BLM SCALAR FIX -Based on findbhudda's original design:
<http://www.midibox.org/dokuwiki/doku.php?id=findbhudda>

KNOWN ISSUES / BUILD SUGGESTIONS:

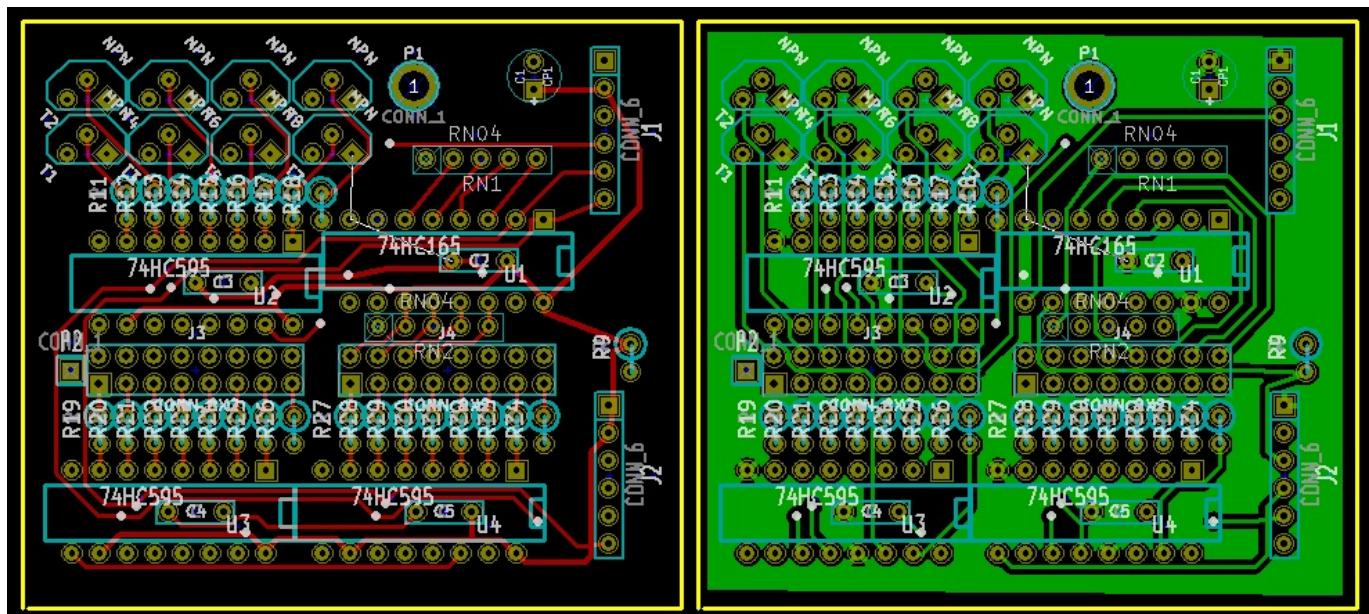
- blm-scalar.* contain an error. Pins I4-I7 are mirrored. This is easily fixed with a connector modification, and the blm-scalar module seems to work as intended.
- blm-scalar v1.1 attempts to fix this error. Moved connectors J1, J2, Resistor Net 1 and R9 to make room for corrections.

Corrected blm-scalar v1.1.brd [blm-scalar_v1.1.brd.zip](#)
